**Application of Future Capital Investment for a Major Modification to zoning conditions pursuant to CZ-20-1243972 to reduce the number of single-family detached lots from 19 to 6 lots in the RSM (Small Lot Residential Mix) zoning district, at 1347 Bermuda Road.**

**PETITION NO:** N10-2022-2260 CZ-22-1246090

### **STAFF ANALYSIS**

| <b>Case No.:</b>  | CZ-22-1246090   | <b>Agenda #:</b> N10   |

## SITE PLAN

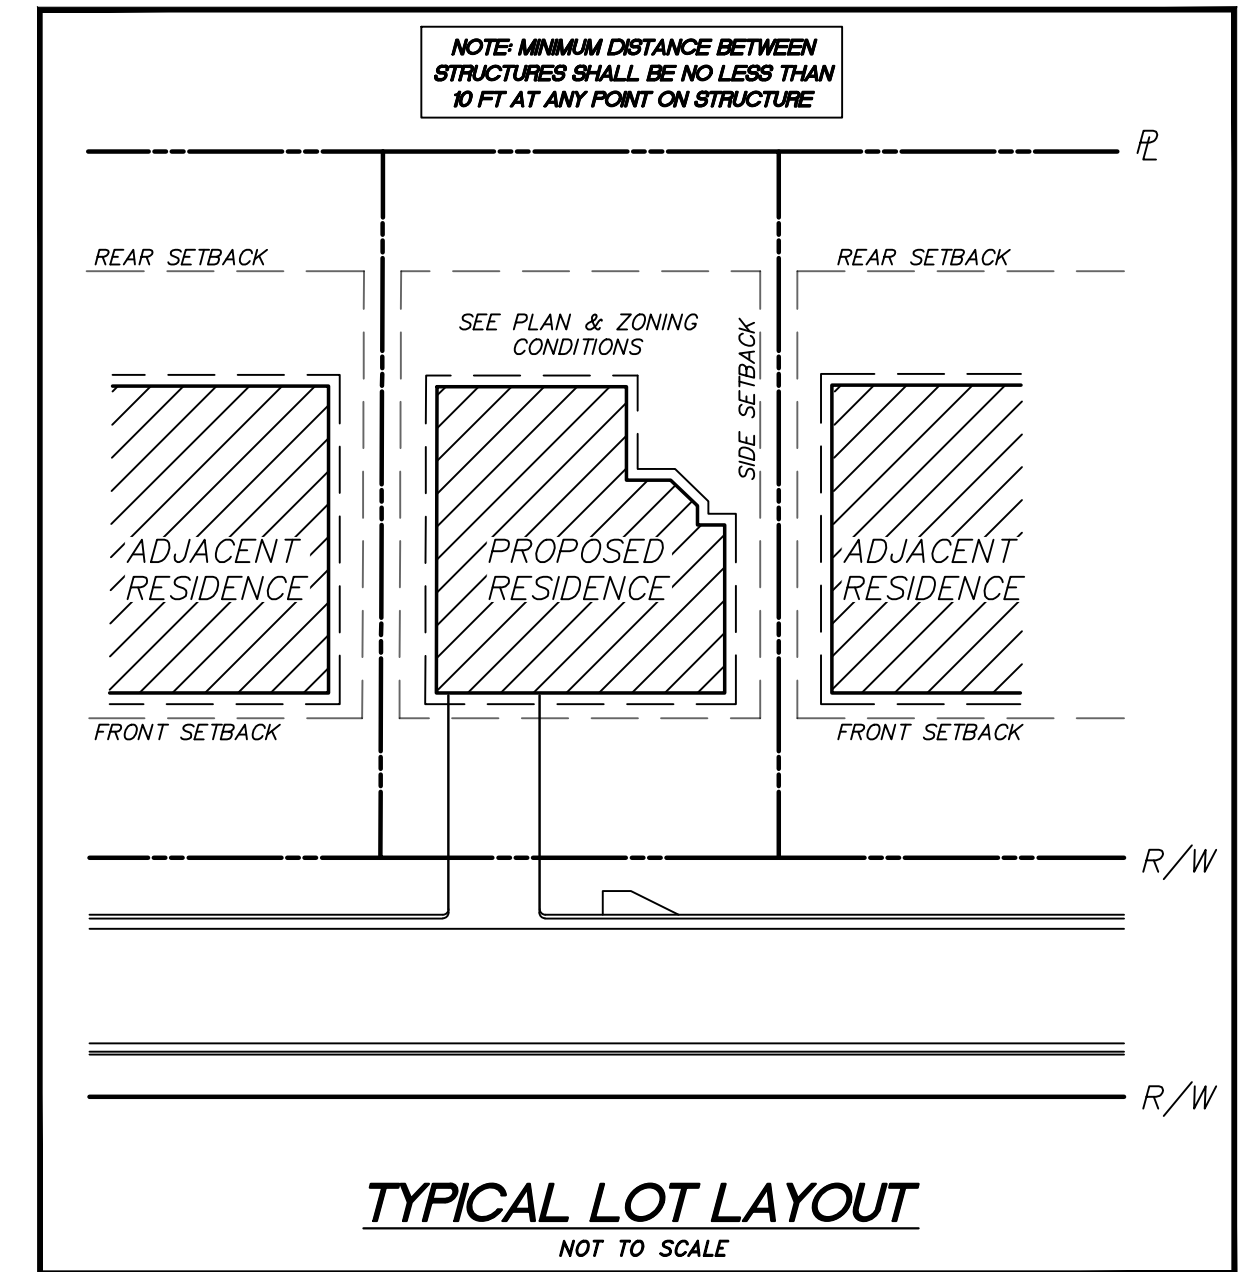
Notwithstanding these positive site plan features, the revised plan proposes a different access and building orientation scenario than what was originally approved. The previously approved plan provided access to all the homes via a new public street with all units facing the interior of the project site, while the proposed plan provides access via a shared access driveway with all units fronting along and facing Bermuda Road (see attached). The Planning Department would prefer that the shared access driveway be relocated behind the proposed homes so that the garages would not be visible to the motoring public along Bermuda Road. The applicant has indicated that while that design scenario would be ideal, the steep topography of the site would prevent that from being implemented. However, the applicant indicates that the project will comply with the Bermuda Road landscaping condition that was previously adopted with the original RSM zoning approval (see Condition #15) which should hide the proposed garages from view as much as possible. The Zoning Board of Appeals (ZBA) will be required to review the proposed shared driveway on its merits since Sec. 5.7.5.F.2 of the Zoning Ordinance allows a maximum of two lots to share the same driveway and the plan shows shared driveway access to six lots.

More information is needed to verify compliance with stormwater management regulations. The Land Development Division indicates that the conceptual plan doesn't indicate the location of the stormwater management facility. The Land Development Division strongly recommends that a design professional investigate the site and identify location where runoff Run-off Reduction Volume (RRV) can be provided and re-design/revise the layout to comply with the RRV requirement (see attached interdepartmental comments from Land Development Division).

Conceptual plan doesn't indicate the location of the stormwater management facility. Location of stormwater management shall be shown or compliance with the County stormwater management regulations shall be explained.

Additional consideration must be given to the 10% downstream analysis. Runoff Reduction Volume shall be provided unless technical justification is provided regarding the unfeasibility. Strongly recommend investigating the site and identify location where RRV can be provided and re-design/revise the layout to comply with the RRV requirement.

Possible Variances: Proposed shared drive will be reviewed to verify compliance with Transportation Department and Zoning Ordinance requirements. From a conceptual standpoint Planning Department would prefer the access drive to provide access to the rear of the proposed lots. Show compliance with RSM requirements including but not limited to minimum lot area and lot width, required parking, parking lot landscaping, minimum open space, maximum building height, transitional buffers, streetscape improvements (sidewalks/street trees/street lighting), building materials, outdoor lighting, etc. The applicant is encouraged to discuss possible transportation improvements that may be required (if the rezoning is approved by the Board of Commissioners) with the county Transportation Department. The applicant is encouraged to contact Land Development Division of Public Works regarding required storm water management, floodplain, and stream

Therefore, it is the recommendation of the Planning & Sustainability Department that the request be "*Deferred Full Cycle*" to allow the applicant time to address the stormwater management regulations and re-design or revise the plan as needed to comply. Should the Board decide to approve the request, Planning Staff recommends the following conditions (additions from the previously approved zoning conditions are in **blue bold**, and proposed deletions are in ~~red strikethrough~~).
